The applicant is requesting to rezone the subject property to the RM3 - Low Density Multiple Housing zone, which is consistent with the Official Community Plan Future Land Use Designation for the subject property (Multiple Unit Residential - Low Density). This zoning would facilitate a proposed 13-unit townhome development.

**Date:** July 8, 2010  
**File No.:** Z10-0051  
**To:** Planning & Development Services Department (LT)  
**From:** Development Engineer Manager (SM)  
**Subject:** 335 Gerstmar Road – LOT 1, PLAN 12346, Sec. 22, twp. 26. ODYD

**RE: Development Proposal at 335 Gerstmar Rd. Plan 12346, Lot 1**  
**RWD File # 10/12 City of Kelowna File # Z10-0051 & DVP 10-0075 & OCP 10-0009**

**SITE PLAN**  
SCALE: 1/16" = 1'-0"

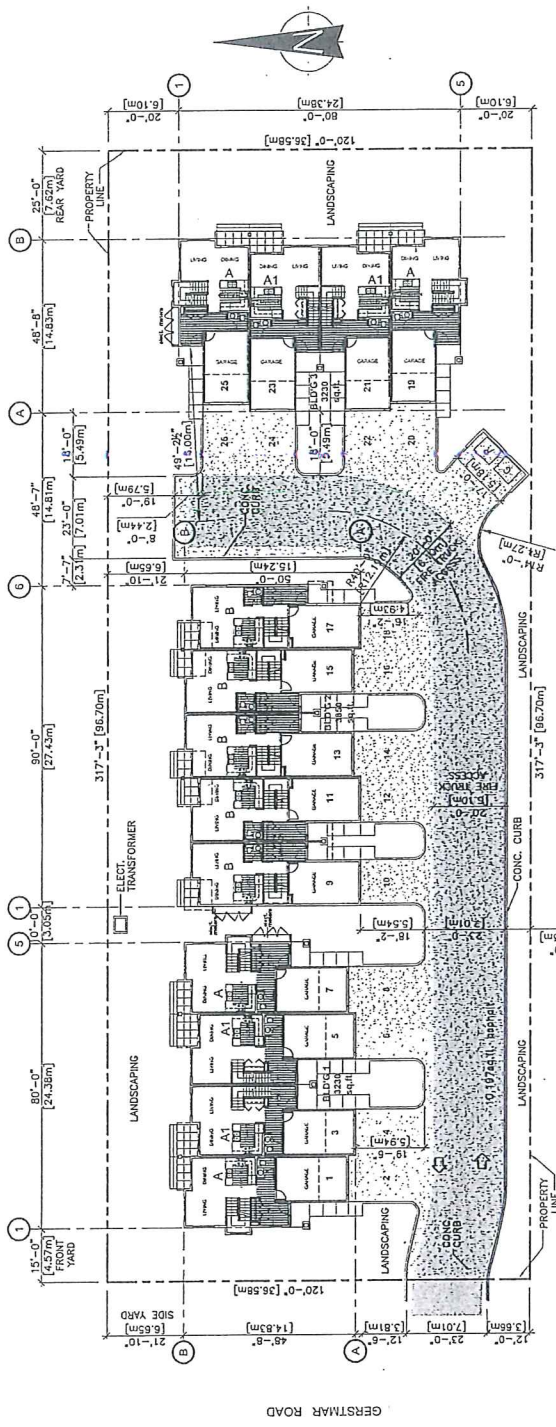
Should Council give favourable consideration to the zone amendment application, a Development Permit and Development Variance Permit would be presented at a later date. The variance requested is for site coverage inclusive of paved areas (54% where 50% is permitted).

Criteria	Proposal	RM3 Zone Requirements
<b>Existing Lot</b>		
Site Area (m <sup>2</sup> )	3539m <sup>2</sup>	900m <sup>2</sup>
Site Width (m)	36.58m	30.0m
Site Depth (m)	96.74m	30.0m
<b>Development Regulations</b>		
Site Coverage (%) [buildings]	27.25%	40%
Site Coverage (%) [including driveways/parking]	54.1% ①	50%
F.A.R.	0.595	0.5 (+ 0.2 for screened parking)= 0.7 FAR
Height (m)	6.477m	9.5m
Storeys (#)	2.0 storeys	2.5 storeys
<b>Required Setbacks</b>		
Front (Gerstmar Rd)	4.57m	4.5m
Rear (east)	7.62m	7.5m
Side (north)	6.65m	4.5m
Side (south)	6.1m	4.5m
<b>Other Regulations</b>		
Private Open Space	40m <sup>2</sup> per unit	$\frac{13 \text{ units} \times 25 \text{ m}^2}{\text{Total: } 325 \text{ m}^2}$
Parking Spaces (#)	26 spaces	$\frac{8 \text{ units} \times 3 \text{ bedroom (2 spaces)}}{5 \text{ units} \times 2 \text{ bedroom (1.5 spaces)}} \\ \text{Total: } 24 \text{ spaces}$
① Indicates a variance to total permitted site coverage from 50% to 54.1% proposed.
